# Port Hope File Factory

A plea for taking more care

Philip Goldsmith | Architect

29th October 2023  
Philip Goldsmith

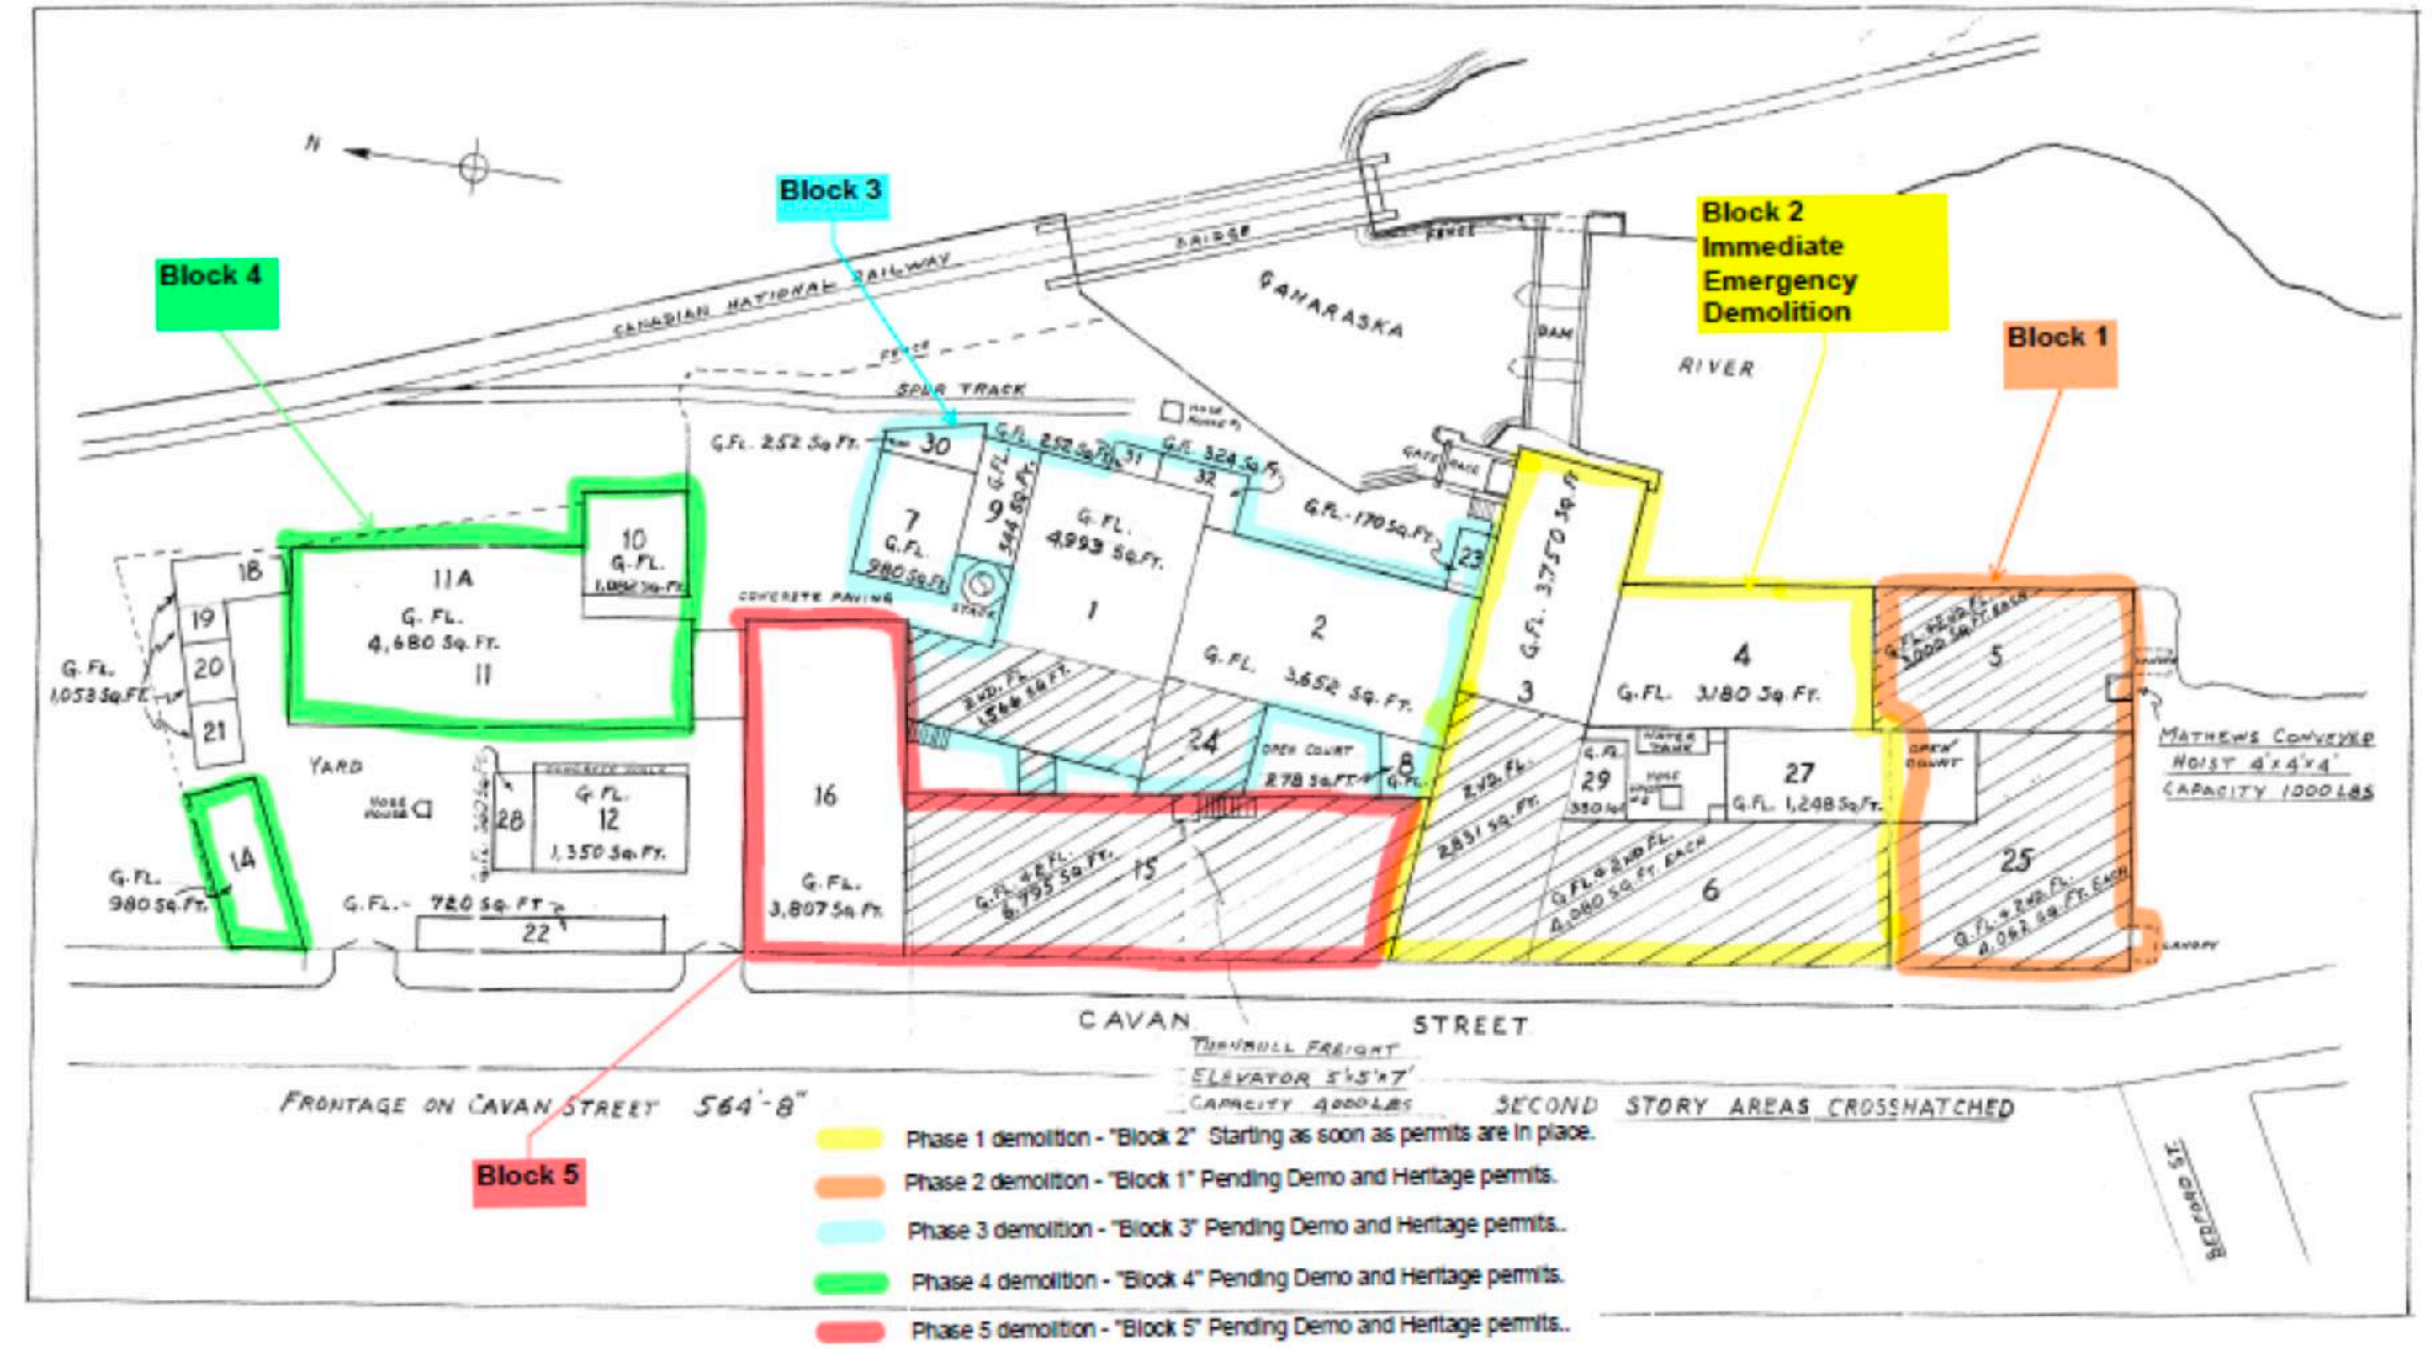
The interior of building 3, the Beamish mill area. The structure is mass stone masonry exterior walls with a heavy timber frame and wood second floor. Rotted wood needs to be removed while the primary frame could be retained, reinforced and jacks added and braced as part of a retention strategy.

The interior of building 4. The structure is mass masonry exterior walls with a primary steel frame and wood second floor. The wood needs to be removed while the steel could be retained and braced as part of a retention strategy.

121 Cavan Street Site Plan (Attachment 6)

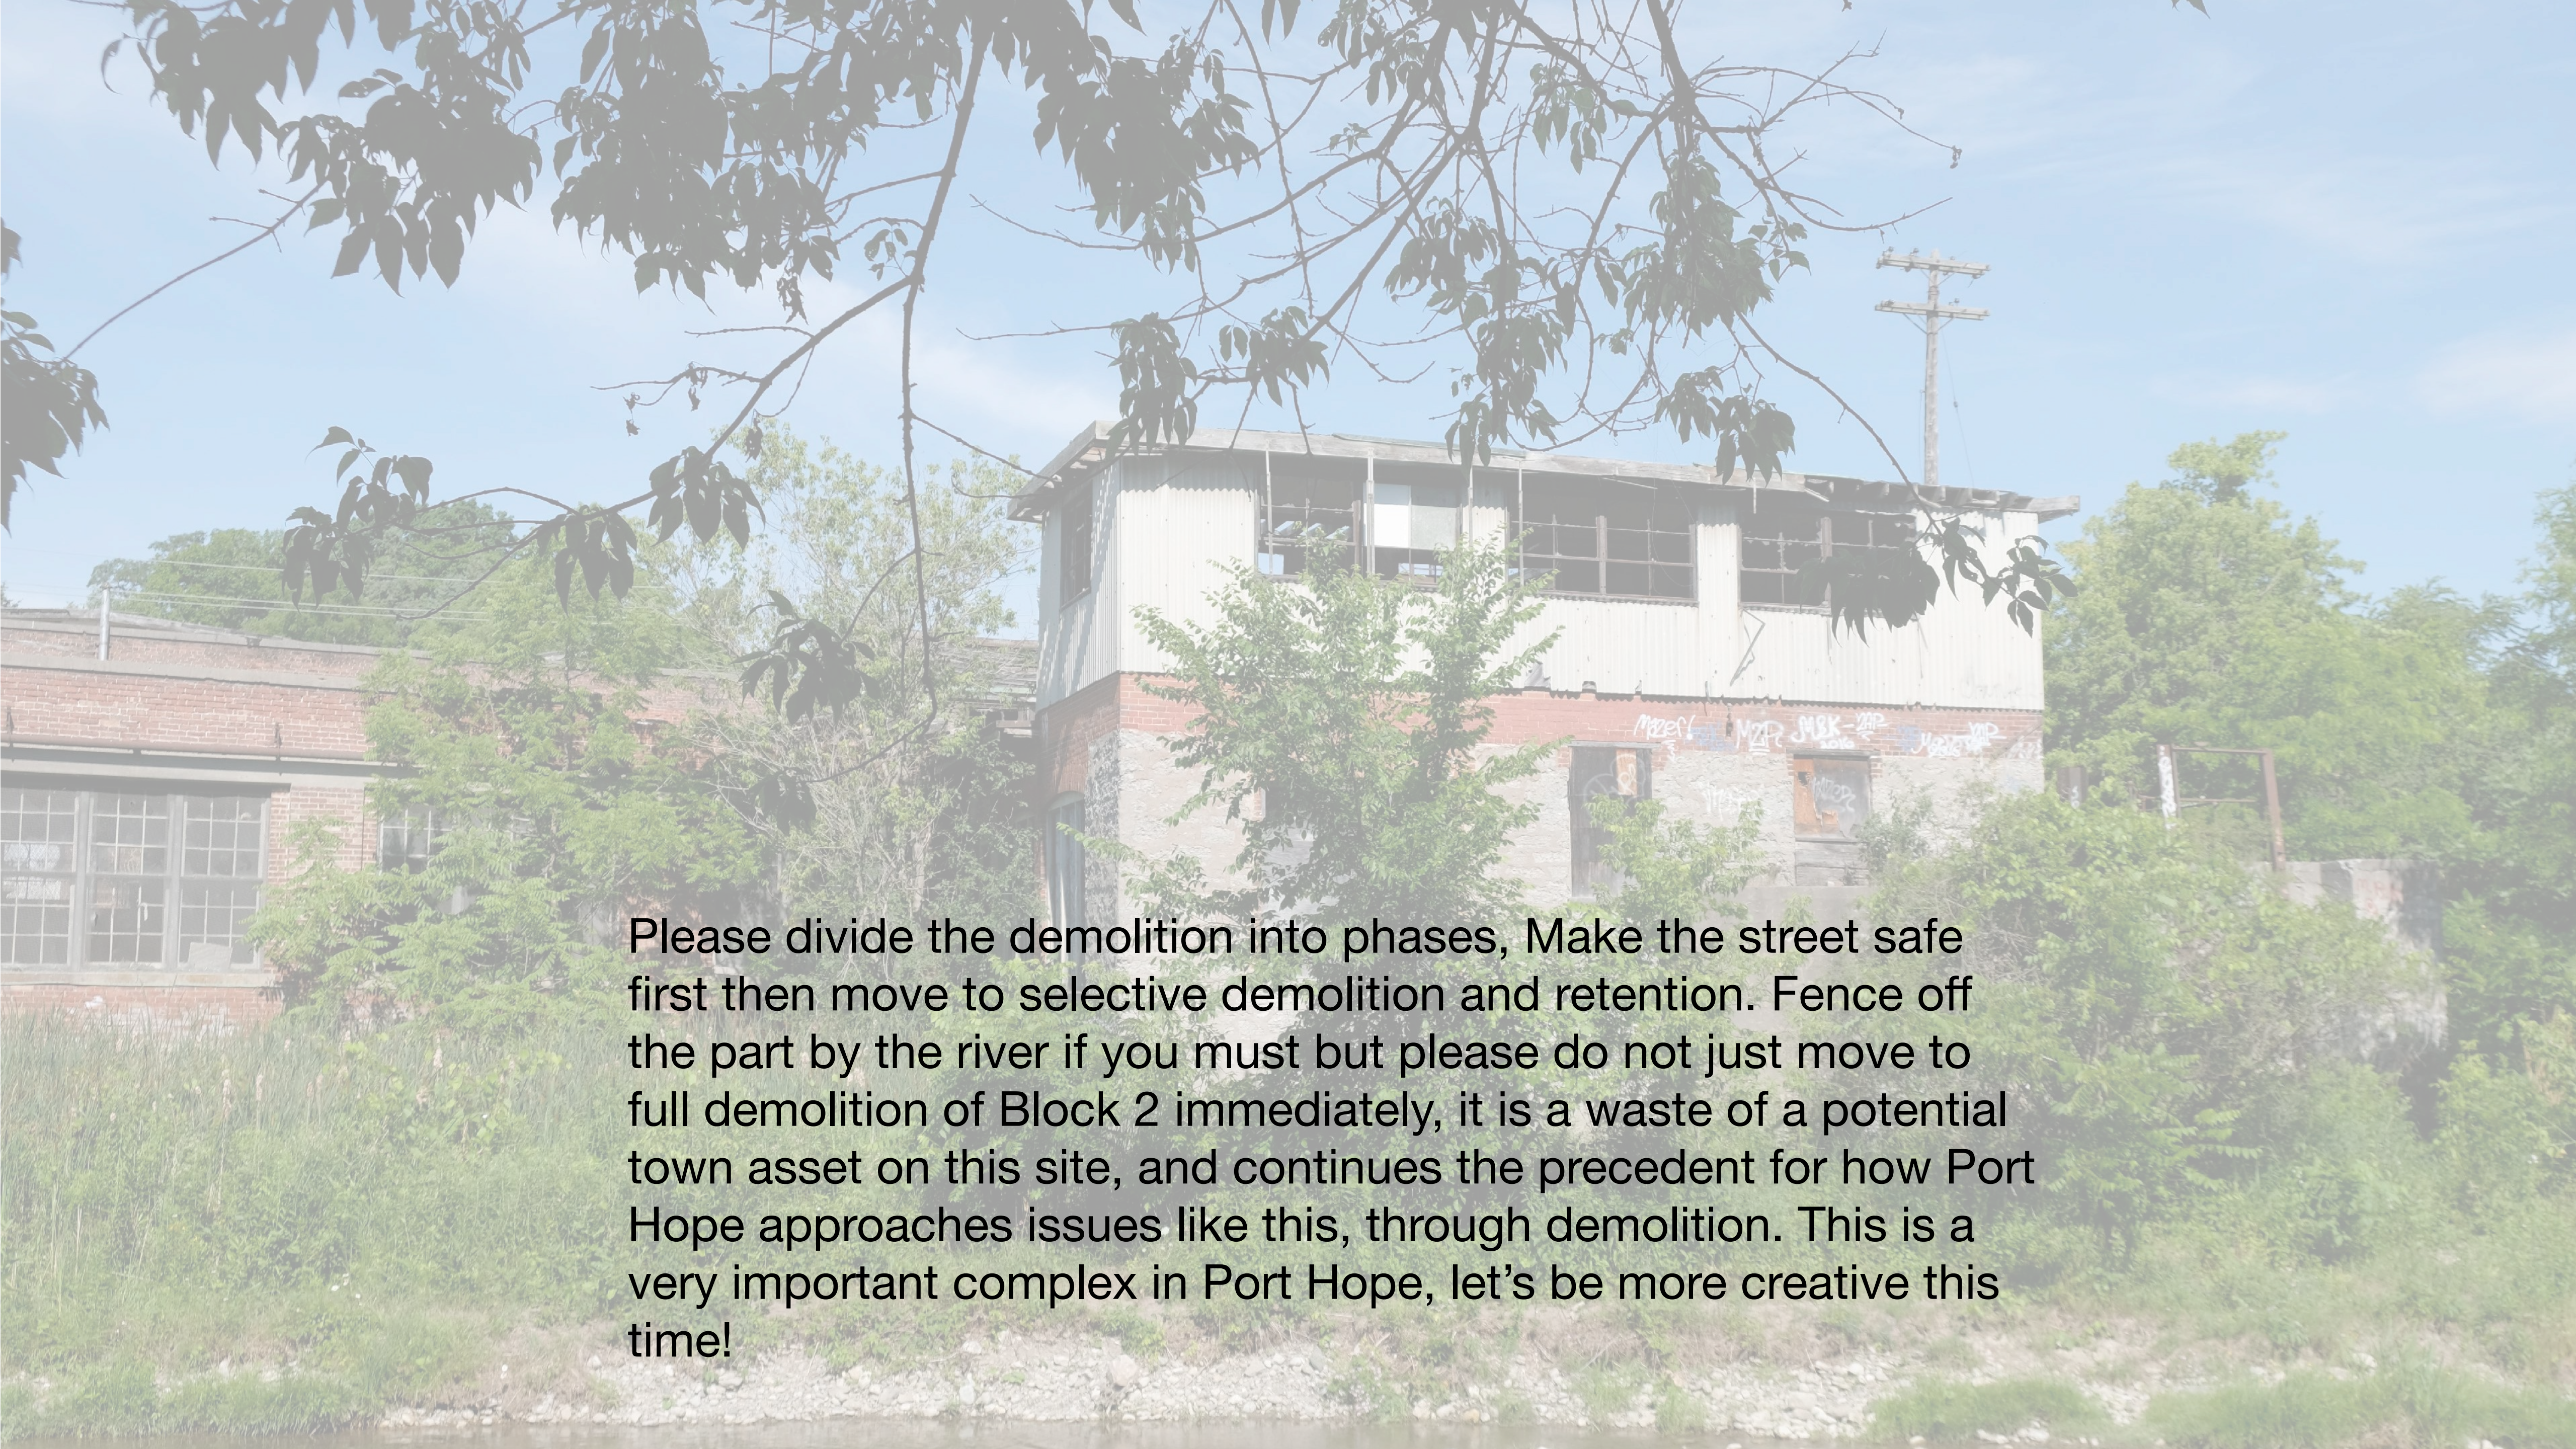
Please divide the demolition into phases, Make the street safe first then move to selective demolition and retention. Fence off the part by the river if you must but please do not just move to full demolition of Block 2 immediately, it is a waste of a potential town asset on this site, and continues the precedent for how Port Hope approaches issues like this, through demolition. This is a very important complex in Port Hope, let's be more creative this time!
